B I D A D D E N D U M 0 4

The items set forth herein, whether of omission, addition, substitution, or clarification are to be included in and form a part of the construction documents for the project listed above.

ORANGE-ULSTER BOCES
AXELROD - MAIN
BUILDING
ADDITIONS +
ALTERATIONS
53 GIBSON ROAD
GOSHEN, NY 10924

8 MILLWORK ELEVATION - FACULTY 513
1/2" = 1'-0"

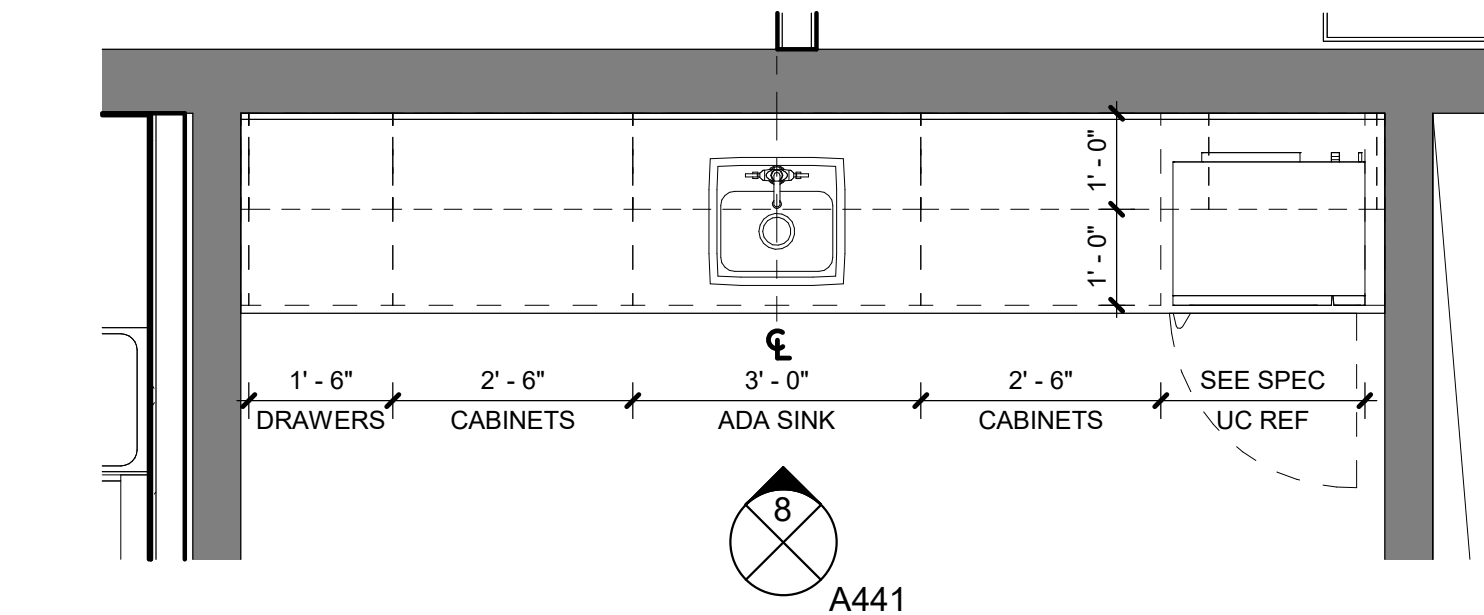
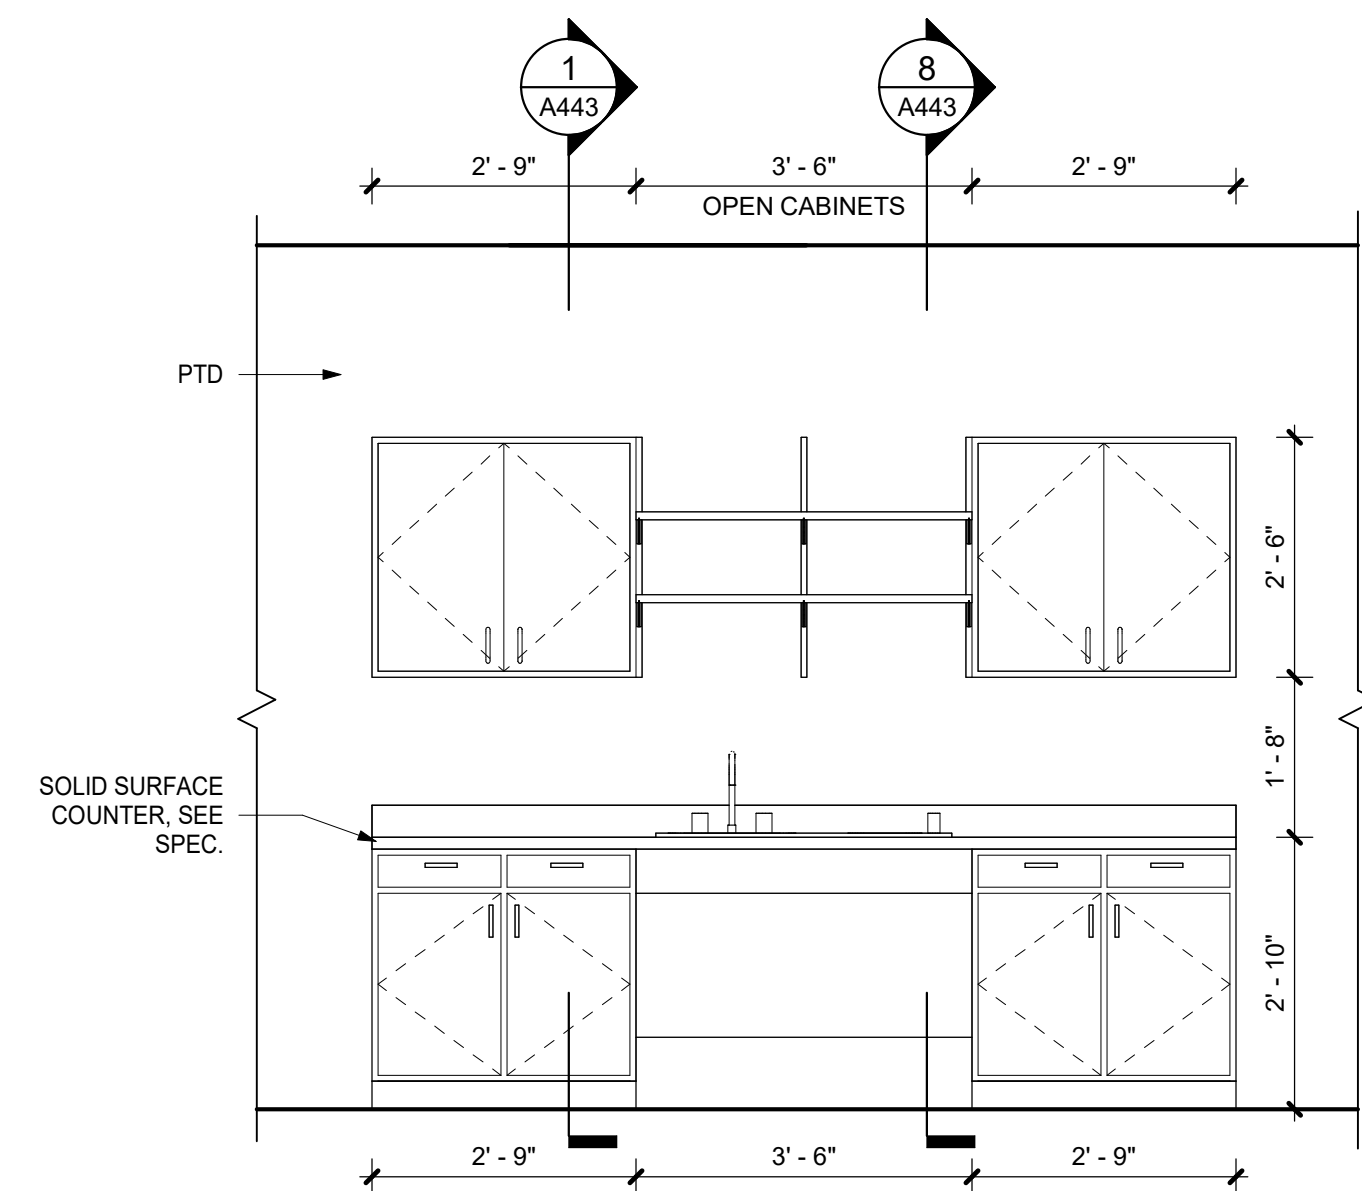
- a. See details 7&8/A441 for millwork to be provided at Faculty Room 513. Millwork shall be provided for full length of wall as shown.
- 4.4 DRAWING A501D – First Floor Finish Plan – Part D

**1ST FLOOR
FINISH PLAN
PART D**

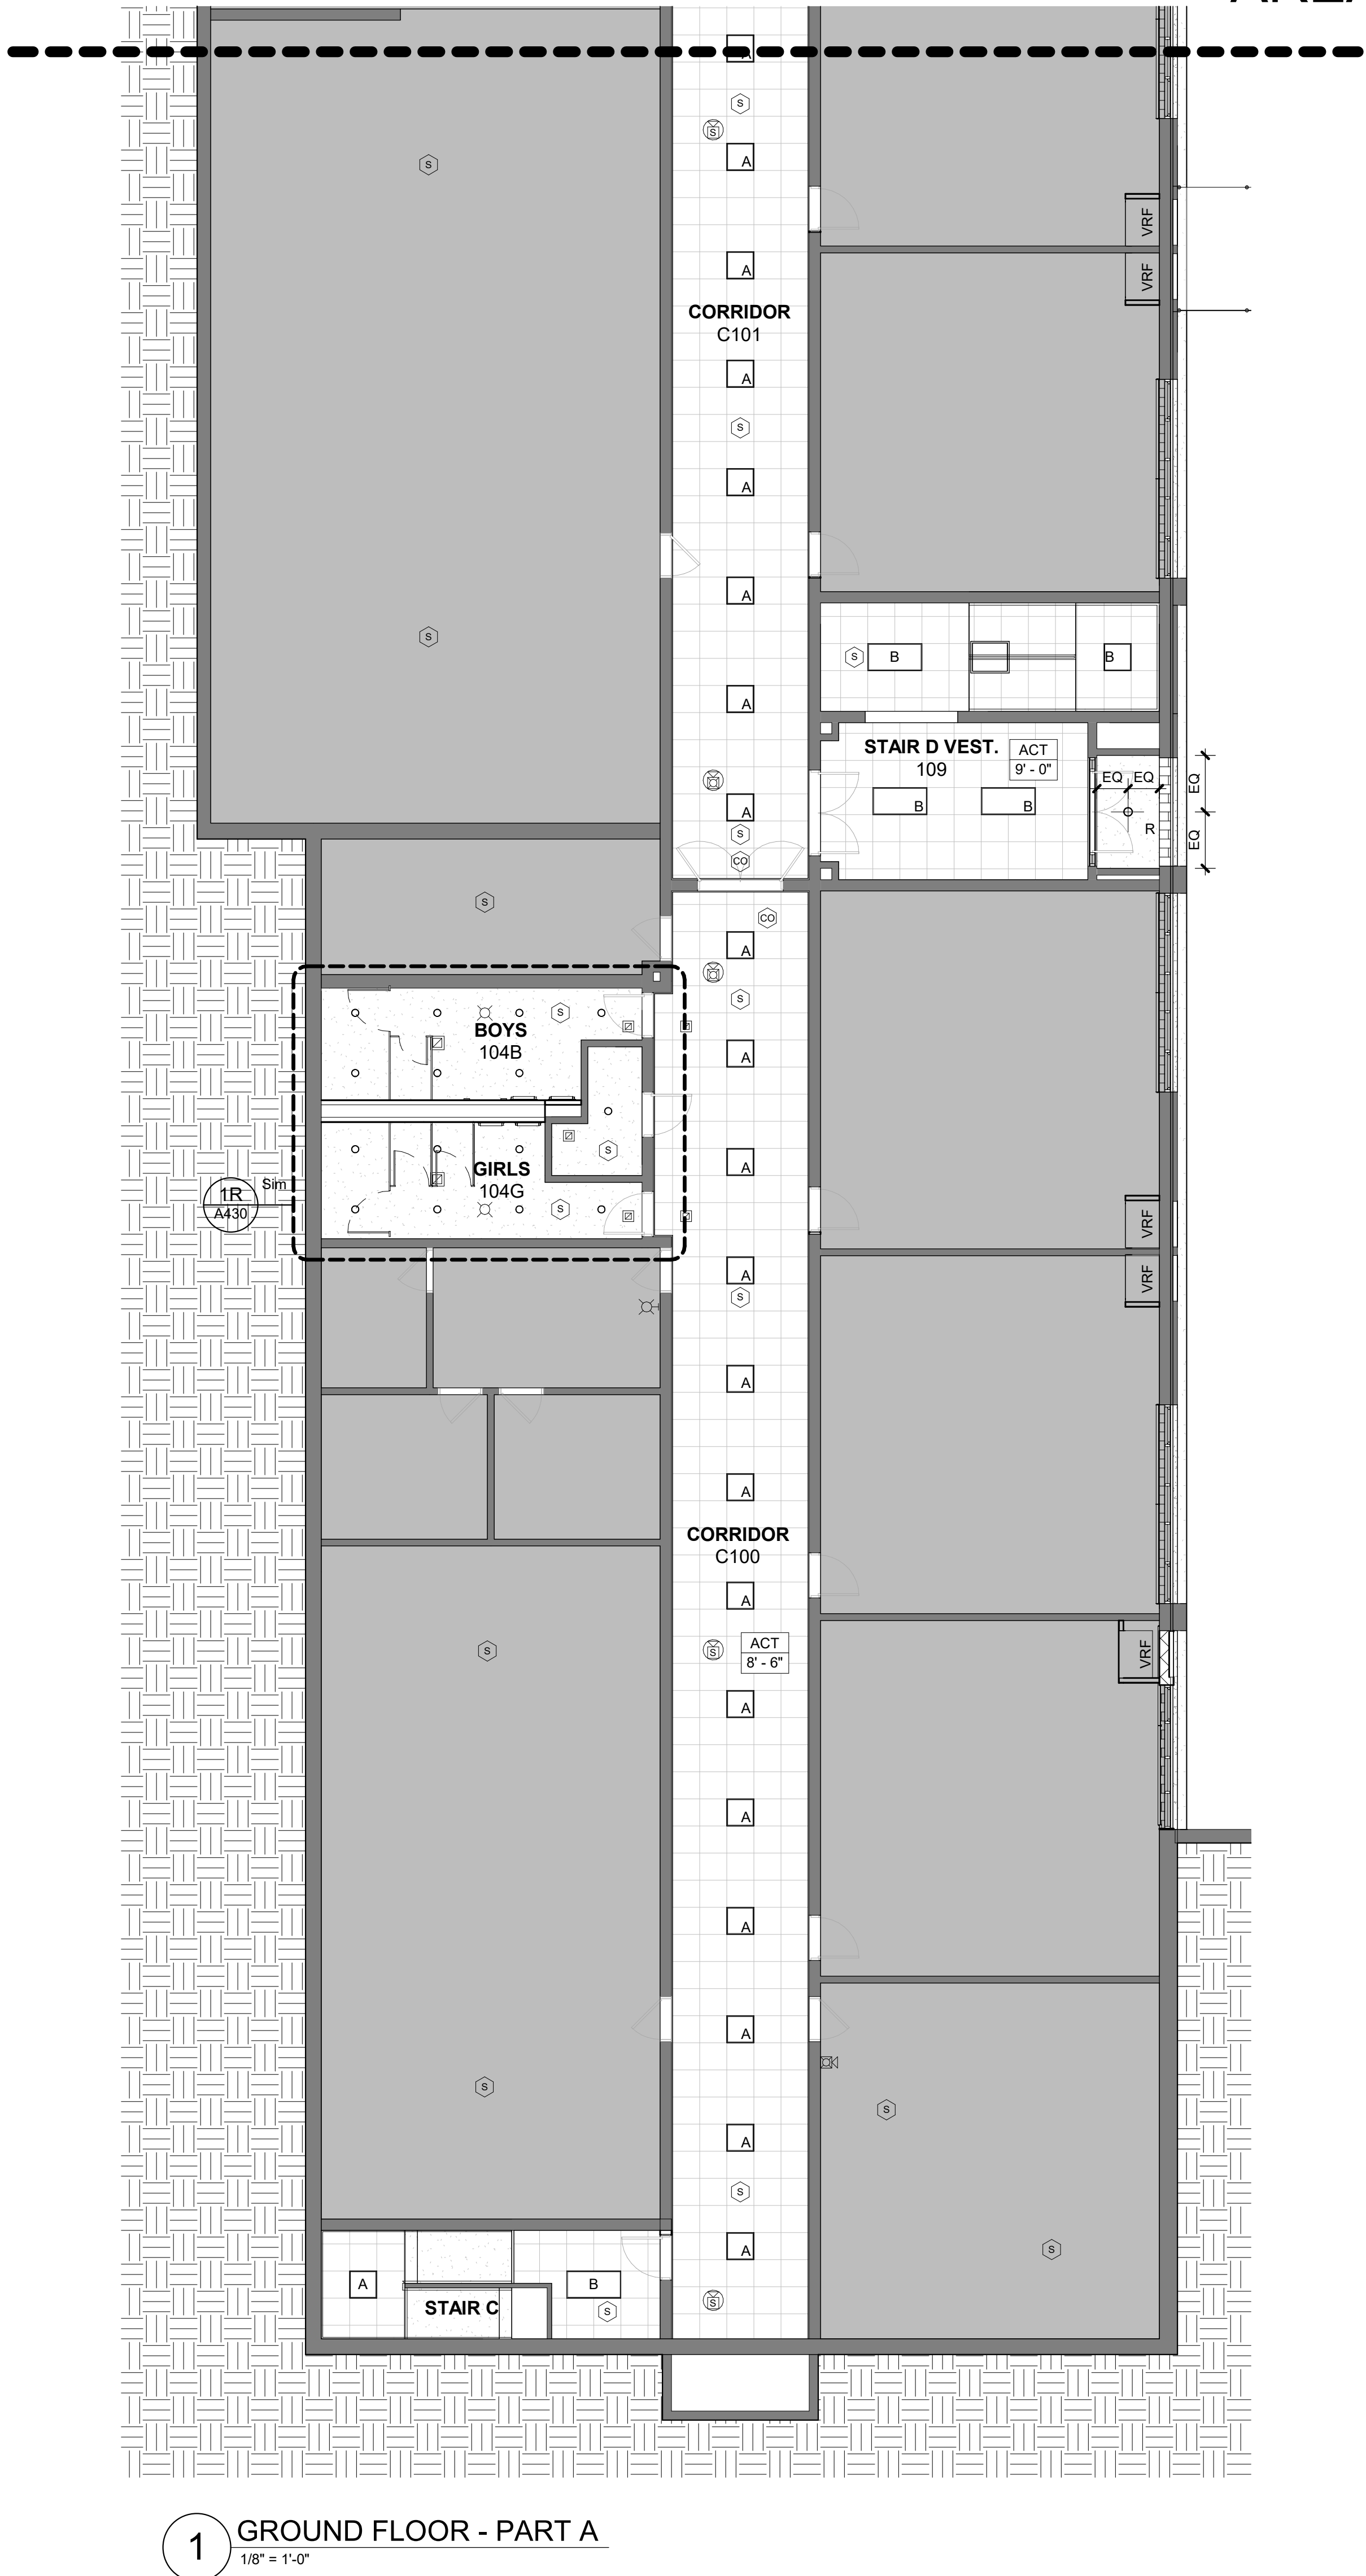
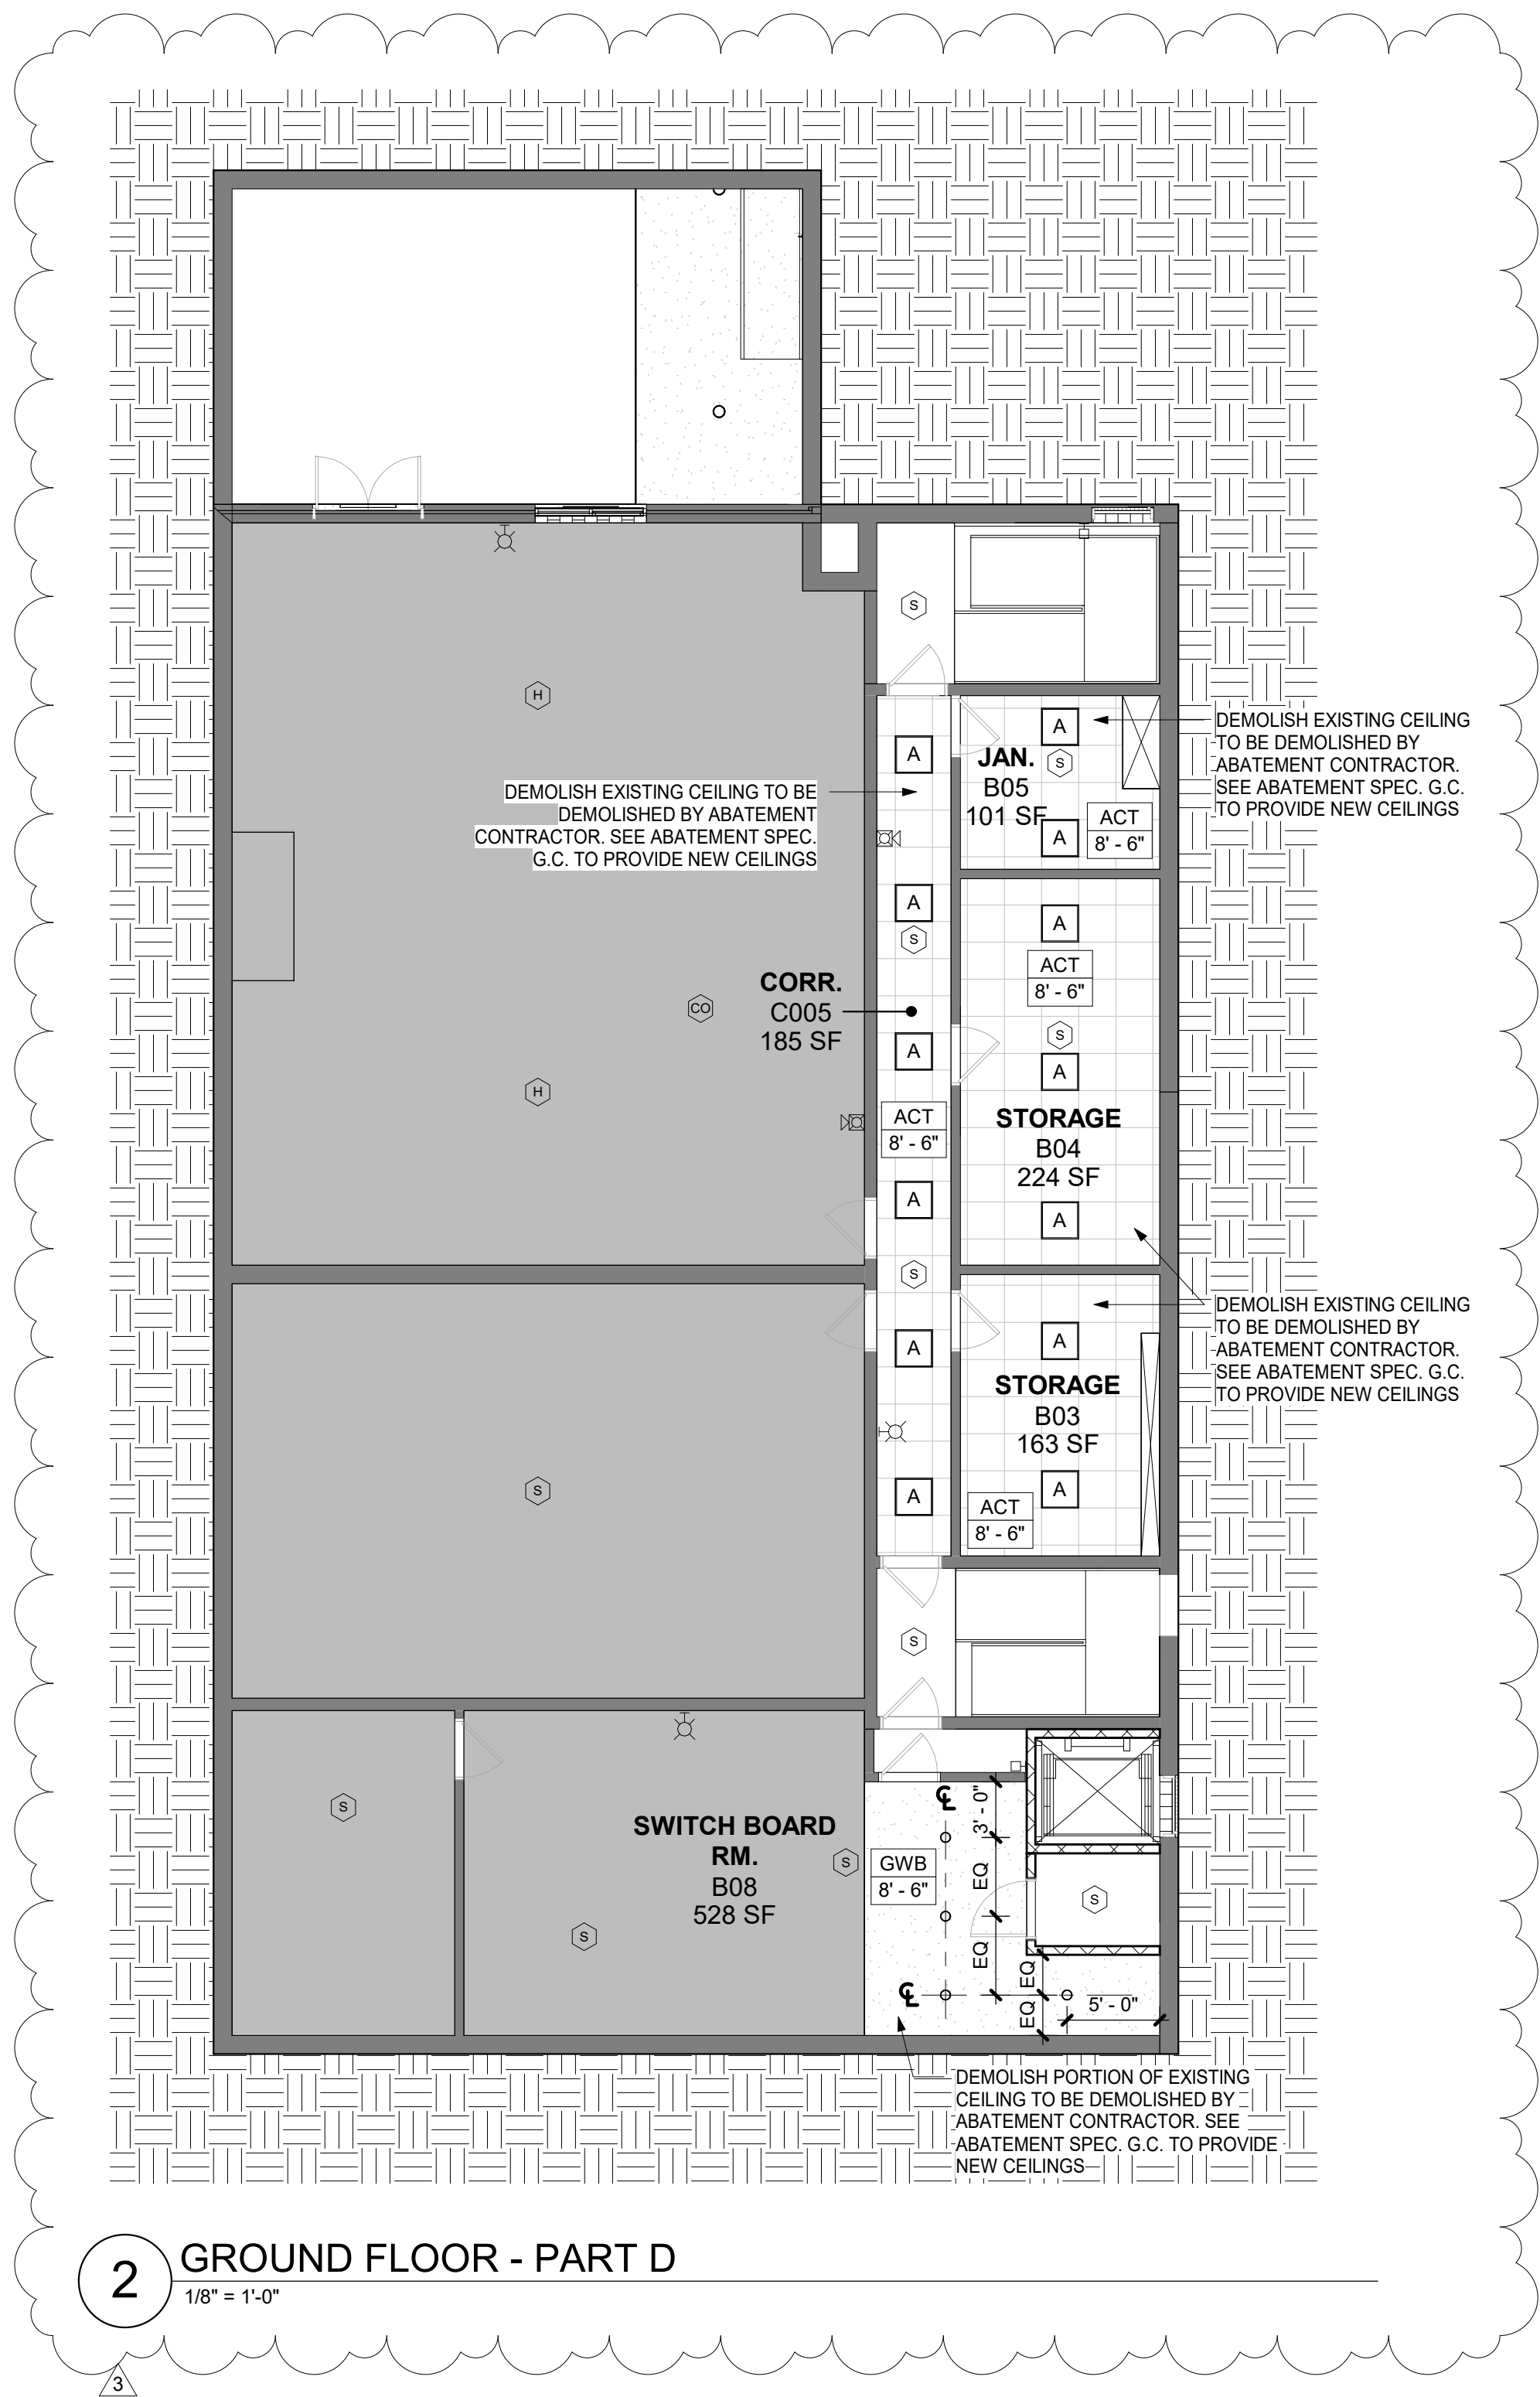
- a. See attached A501D with revisions to floor pattern at corridor and classrooms of the 500-wing.
- 4.5 DRAWING A600A – Ground Floor Ceiling Plan Part A&D
